**N5242A-07**

**S E R V I C E N O T E**

**N5242A PNA Series Microwave Network Analyzers**

**Some analyzers are exhibiting unlocked or unlevelled errors or other unexpected digital control faults. Analyzers that experience any of the symptoms listed on page 2 of this document must be inspected for a possible return to Agilent to have the system motherboard replaced.**

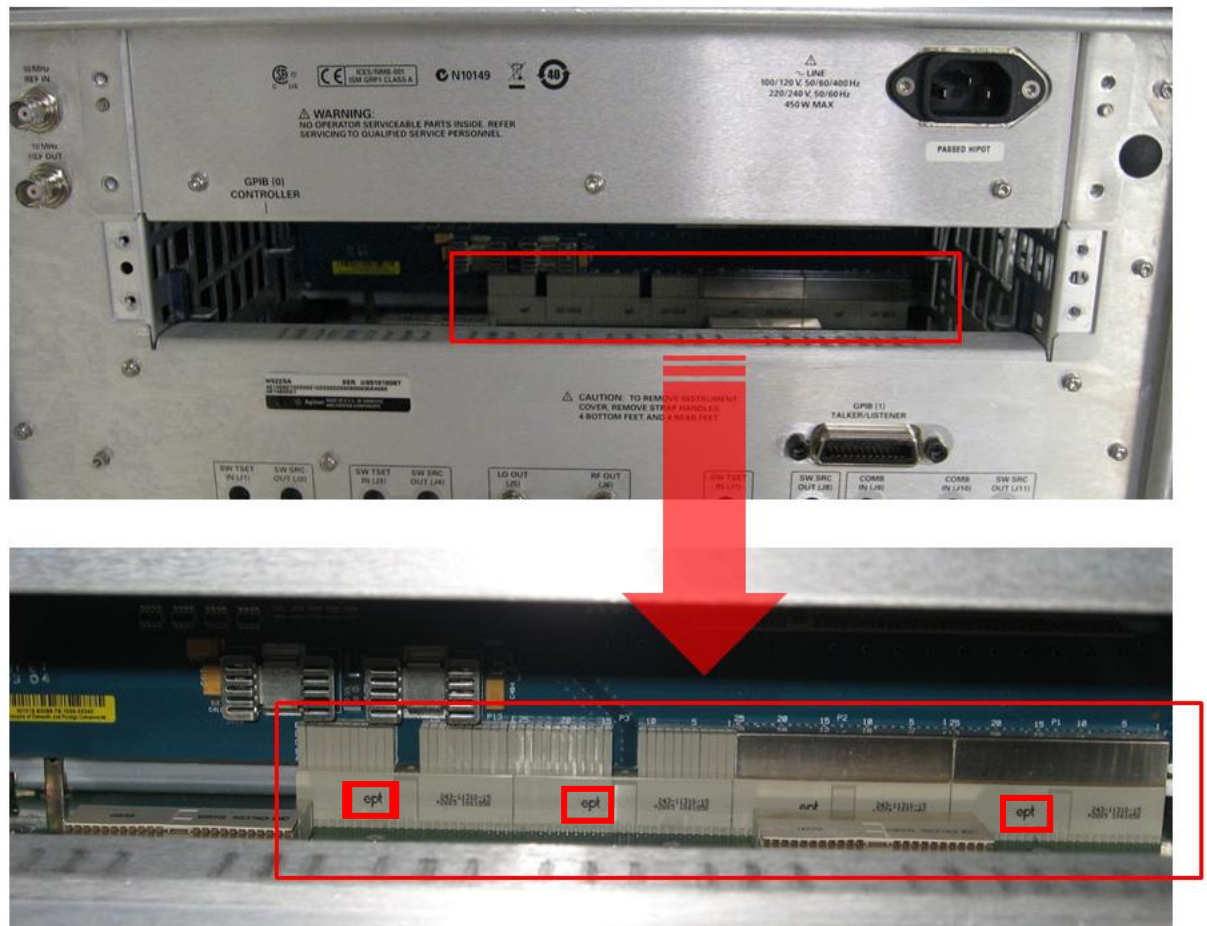
1. Remove the CPU assembly from the analyzer's rear panel. Refer to the PNA Service Guide chapter 7 section titled, "Removing and Replacing the CPU Board Assembly" for removal and reinstallation procedures. To view the online Service Guide, see the numbered list on the next page for instructions.
2. As per the photo below, inspect the system motherboard connector to see if it has one or more "ept" logos.

3. If the connector has one or more “ept” logos, return the analyzer to Agilent for replacement of the system motherboard. If the connector does not have one or more “ept” logos, email [support\\_ctd-soco\\_support@agilent.com](mailto:support_ctd-soco_support@agilent.com), providing the analyzer model and serial number and details of the malfunction symptoms.

4. *For Agilent Service Technicians only:* Only new boards without “ept” logos should be installed. Before installing the new board, look to see if it has one or more “ept” logos. If so, email [support\\_ctd-soco\\_support@agilent.com](mailto:support_ctd-soco_support@agilent.com), providing the analyzer model and serial number. Wait for further instructions in an email reply. New boards without “ept” logos can be installed.  
For installation instructions, refer to the PNA Service Guide chapter 7 section titled, “Removing and Replacing the System Motherboard.” To view the online Service Guide, see the numbered list on the next page for instructions.
